proposed roof plan

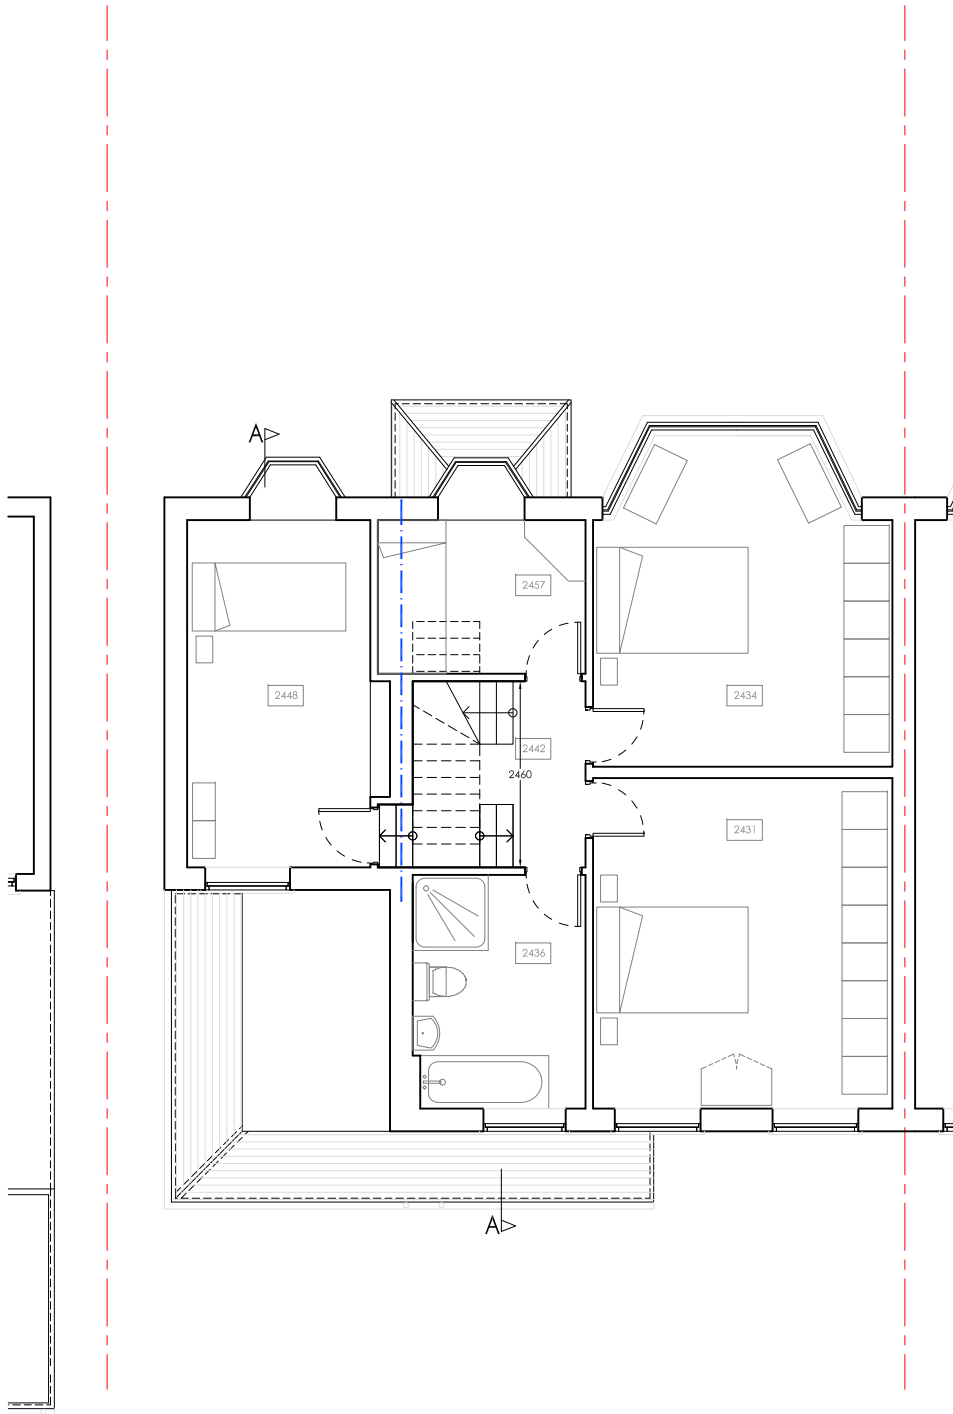
rev01: 30/08/20 - dormer set in by 300mm from shared boundary after planner's comment.
